AD No: 2006-0317
16 October 2006

MANDATORY BULLETIN
No BE-057/SZD-50-3/2006 „PUCHACZ”

DESIGNATION-TYPE/MODEL: SZD-50-3 “PUCHACZ”

CONCERNS: Introduction of an extra pull rod segment in the rudder control system

Fig. 1

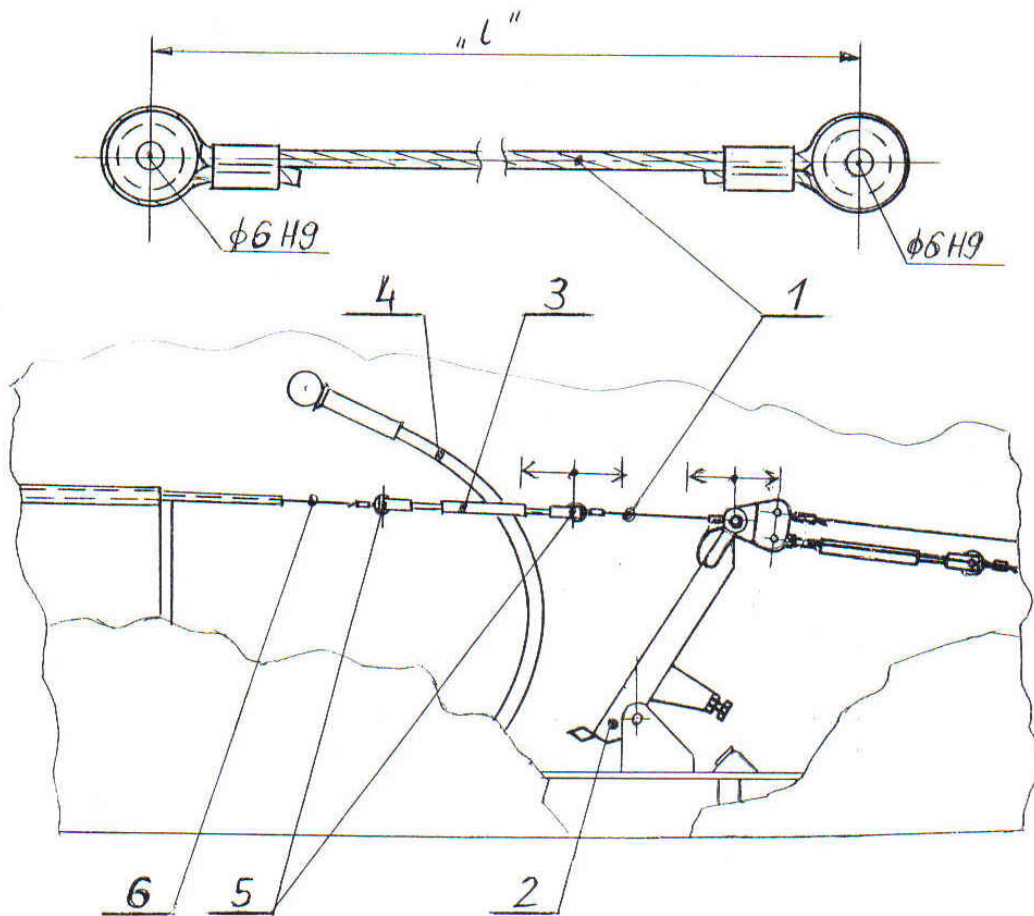
Herewith, an extra segment of pull rod ((1) – Fig (1), of approx 140mm length “I”, is being introduced between the rear pedals (2) and turnbuckle (3) of pull rod connected to a rudder.

This modification is aimed at elimination of the lateral load component applied at turnbuckle terminal by {pilot} foot. In several instances this has brought to fatigue failure and break of the terminal at the site of transition into eyelet.

- 4.1 , On the gliders, where the eyelet terminal of the turnbuckle is connected directly to the pedals, the terminals are to be disconnected from the left-, and right pedal and scrapped. The eyelet type terminals are to be replaced with fork type with the same thread (right/left hand).

- 4.2 Between the pedals (2) and turnbuckle (3), install a short pull rod (1) of aircraft type steel cable with 3 mm diameter core and approx 140mm length “I”. The length is to be adjusted so that the shield of the wheel brake pull rod (4), on a left side board, remains between the turnbuckle lateral screws (5) over the whole travel of turnbuckle (fore-aft).

- 4.3 Shorten the pull rods (6) connecting a rudder with rudder by a value obtained by adding the length of extra pull rod with a difference between the eyelet- and fork terminal lengths.

- 4.4 The M4 nuts, securing the connection between the pull rod and pedal are to be of a castellated, thin type with 1 mm diameter cotter pin.
